CITY PLANNING COMMISSION

- A. Negative Declaration
- B. Tentative Map to divide 16.1+ acres into 81 standard single family lots to be called Mesa Grande Unit 8 in the Standard Single Family (R-1) zone

TENTATIVE SUBDIVISION MAP
MESA GRANDE UNIT NO. 8
 City of Sacramento, California

P-89-093

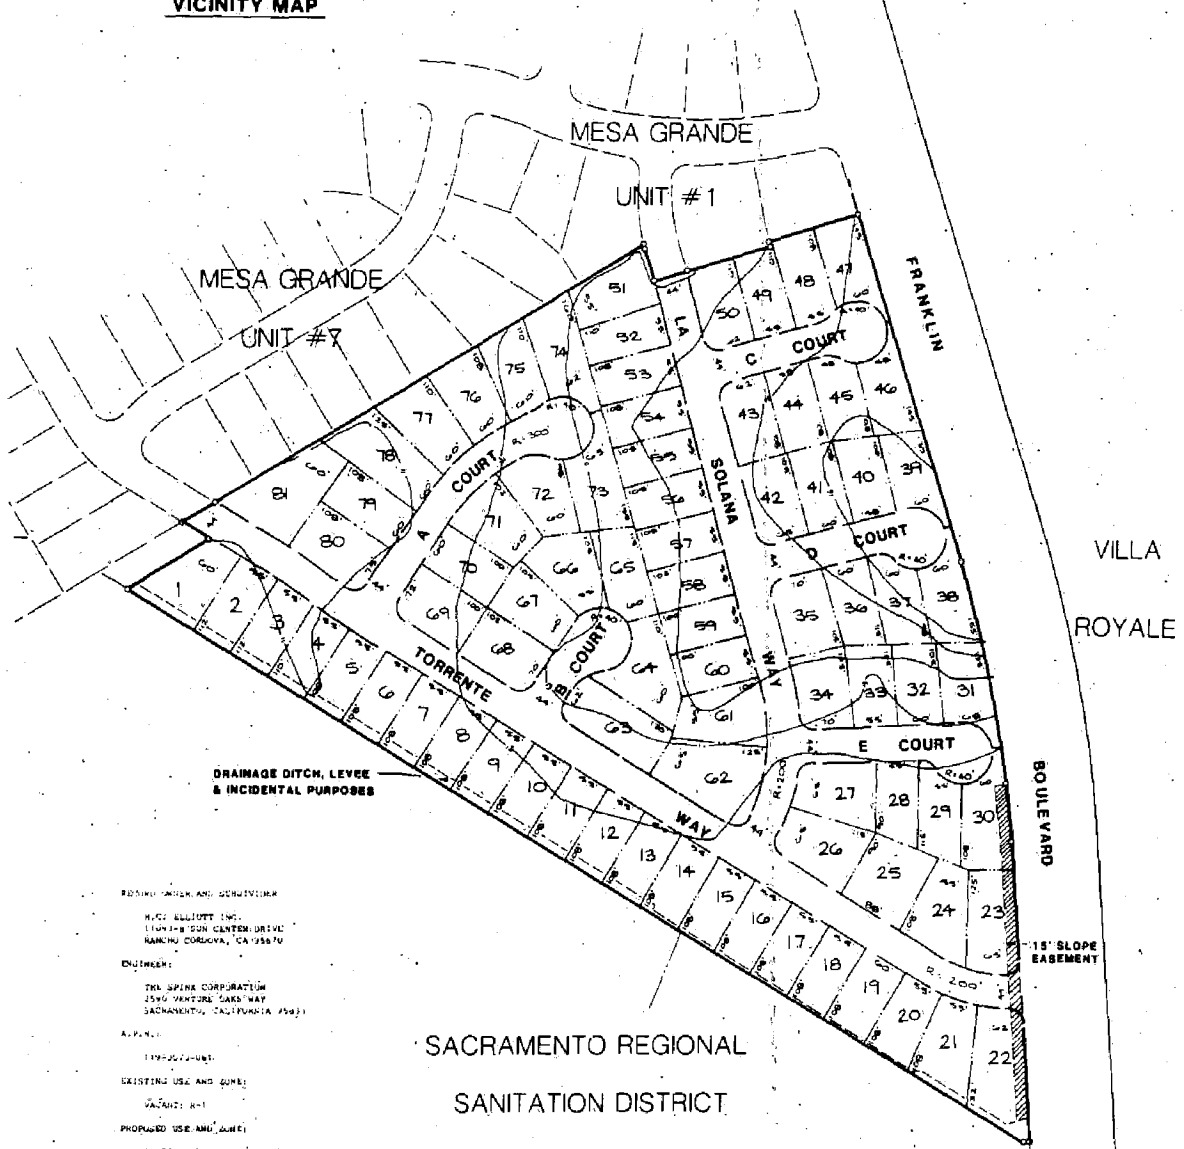
Access to the site will be provided via Valley Hi Drive to the north or through one street off Franklin Boulevard (proposed Torrente Way). City Traffic Engineering has expressed concerns over the future median improvements along Franklin Boulevard north of the Union House Creek bridge and Valley Hi Drive and the location of the entrance off Franklin Boulevard.

Lots adjacent to Franklin Boulevard are designed to be side-on lots with cul-de-sacs servicing the lots. Similar lot layout was constructed in Mesa Grande Unit 1 to the north. Side-on lots are preferred over back-on lots on major streets as stated in the 1986 South Sacramento Community Plan.

The applicant proposes an 81 unit standard single family subdivision in the R-1 Zone. All proposed lots meet the minimum dimensions and lot area requirements in the R-1 Zone. No floor plans or elevations for the dwellings were submitted with the tentative map request. A 15 foot wide slope easement is proposed along lots 22, 23, and 30 for the ramp up to the bridge over Union House Creek. Access to Franklin

Boulevard from Torrente Way may require relocation to the satisfaction of the City Traffic Engineer due to its proximity to Union House Creek or plans for the median along Franklin Boulevard.

Staff and the Subdivision Review Committee have reviewed the proposed design and support the proposed lot layout. The further study of right-of-way for Union House Creek is required by the Public Works Department. The results of the study may require redesign of lots adjacent to Union House Creek.

1. Provide standard subdivision improvements pursuant to Section 40.811 of the City Code (includes Franklin Boulevard frontage);
2. Prepare a sewer and drainage study for the review and approval of the City Engineer;

12. Construct improvements on Franklin Boulevard as per plans on file with the City Public Works Department;
13. Torrente Way to be dedicated to a 50 foot right-of-way between Franklin Boulevard and Solana Way. (Note: Franklin Boulevard will have a center median without a break at Torrente Way.);

15. Right-of-Way Study required for Franklin Boulevard (120 ft R/W);
16. Applicant shall coordinate Franklin Boulevard improvement with Public Works Department - Engineering Division; Median improvements are currently under design;

17. Annex to Regional Sanitation District and pay necessary fees;
18. Right-of-Way study required for Union House Creek. Additional easement dedication may be required to the satisfaction of the Public Works Department Flood Control Division;
